AGENDA
Cascade Charter Township Planning Commission
Monday, February 18th, 2019
7:00 pm
Cascade Library Wisner Center
2870 Jacksmith Ave. SE

STAFF REPORT: Case # 19-3516
REPORT DATE: January 23, 2019
PREPARED FOR: Cascade Charter Township Planning Commission
MEETING DATE: February 18, 2019
PREPARED BY: Steve Peterson, Planning Director

REQUESTED ACTION: Basic Plan Review for an amendment to the PUD to accommodate a new 136,000 office building

C2.0

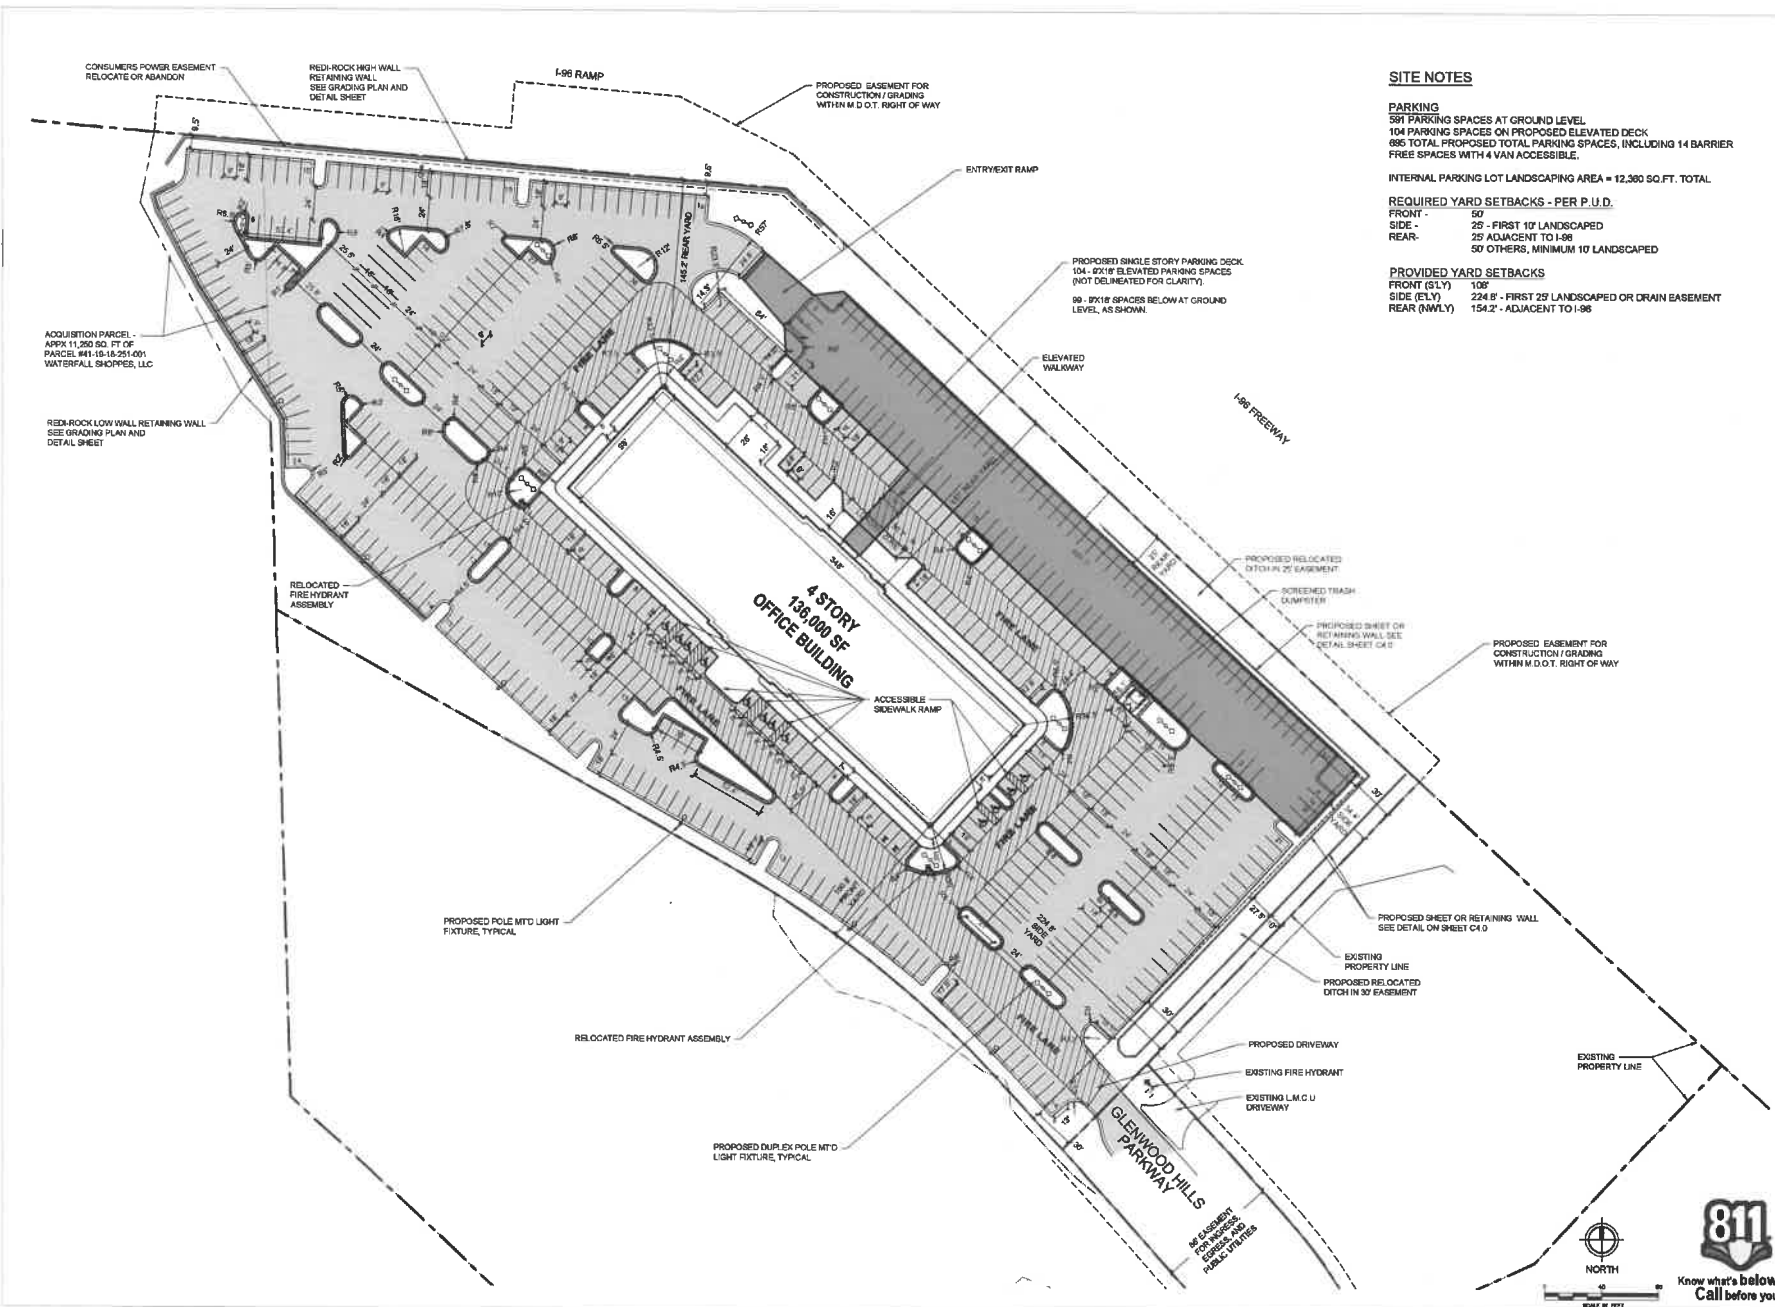
6. The developer now is proposing a 4-story 136,000 sq ft office building. With a one-story parking garage. The developer has indicated the total height of the building to the roof line is 58 feet. This is 8 feet taller than was originally allowed and 13 feet taller than the underlying industrial zone around it. One of the standards for the PUD rezoning /amendment is the benefit to the community for the PUD changes. The developer should be prepared to offer benefits and a rationale for the additional height as described in Section 17.07.s of the zoning ordinance.

10. The developer will also need to provide some information about the proposed use so we can calculate the necessary parking. According to our ordinance they have an extra

262 parking spaces over what we allow which would create the need for extensive parking lot landscaping.

1. Elevation plan for the parking deck
2. KCRC review and approval of road vacation/road design
3. Photometric plan
4. Approval from MDOT for grading on their property
5. Agreement from neighboring property for the reconfiguration of the property lines
6. Approval from the township engineer for storm water plan
7. Approval from the KCDC for the drain relocation
8. Rationale/community benefit for building height additional parking.

SKETCH OF DESCRIPTION PORTION OF GLENWOOD HILLS PARKWAY TO BE VACATED

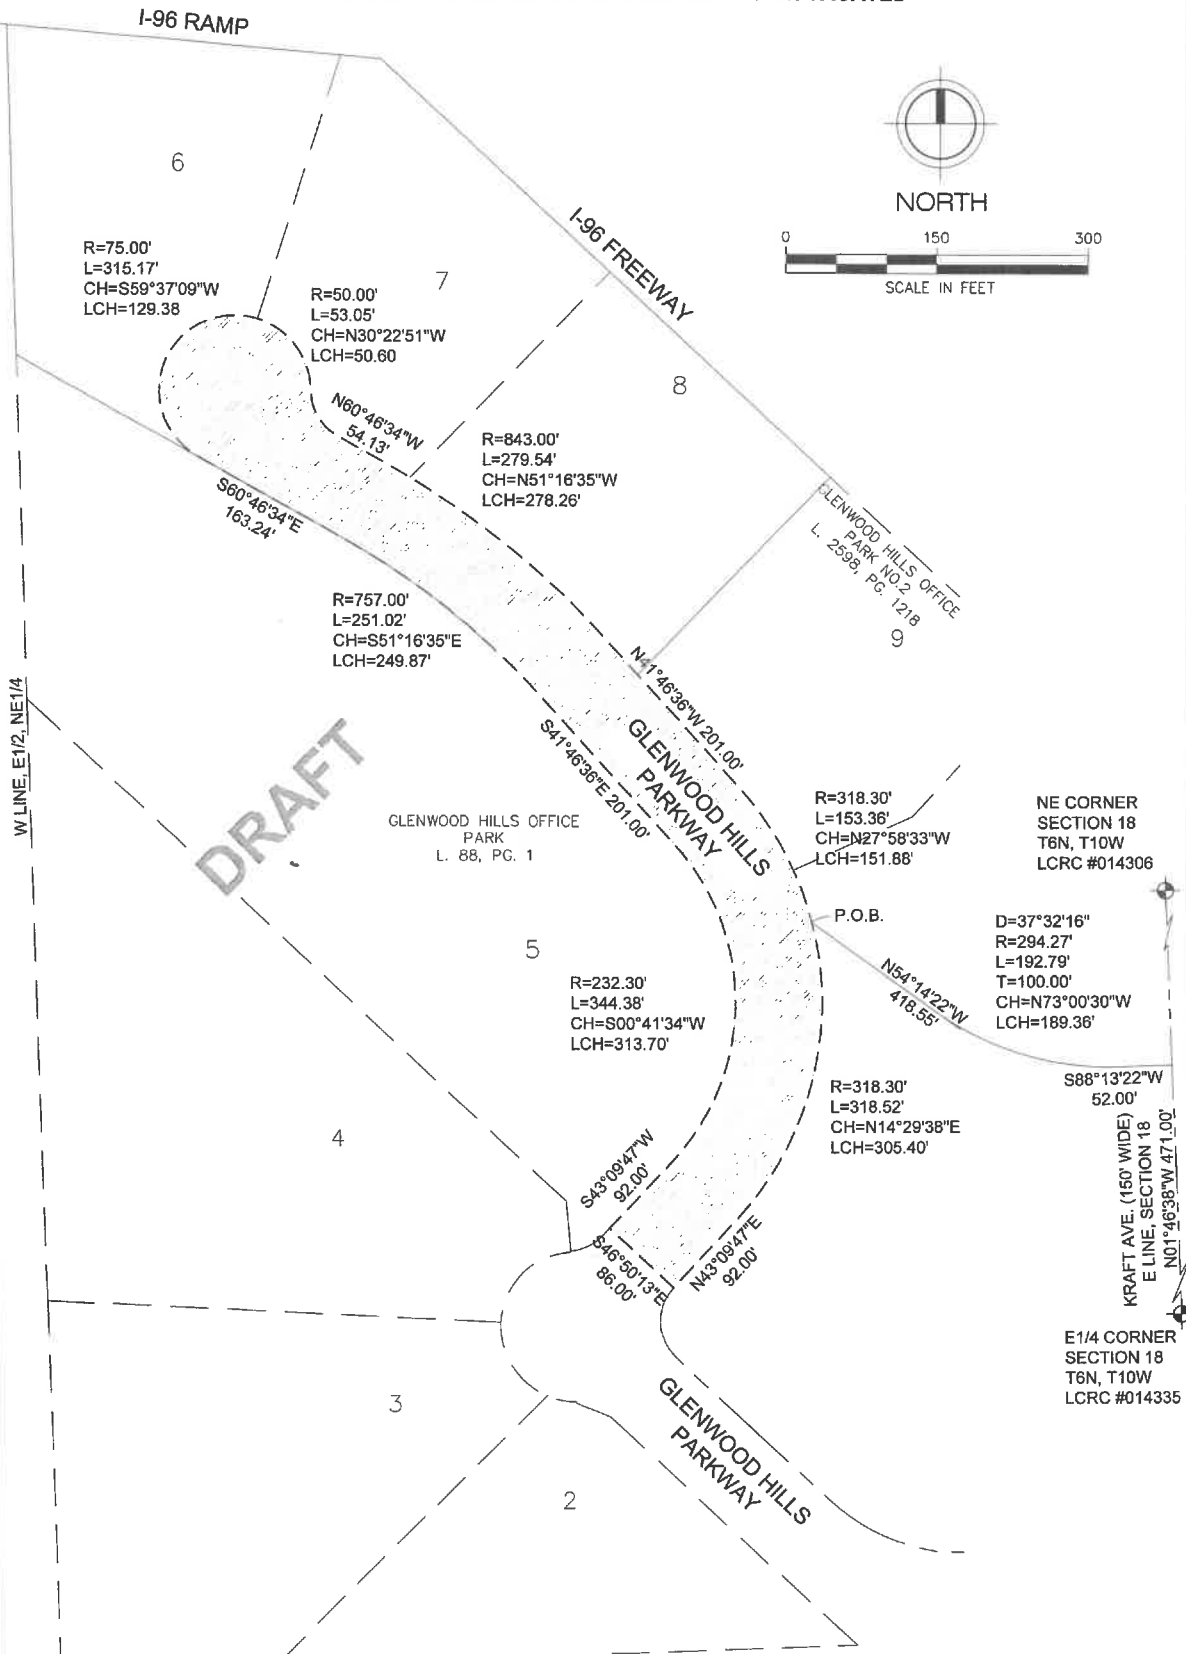
7. The new project also includes the vacation of a portion of Glenwood Hills Parkway. The developer will need to complete this before any permits can be issued but it can happen concurrently with the PUD amendment.
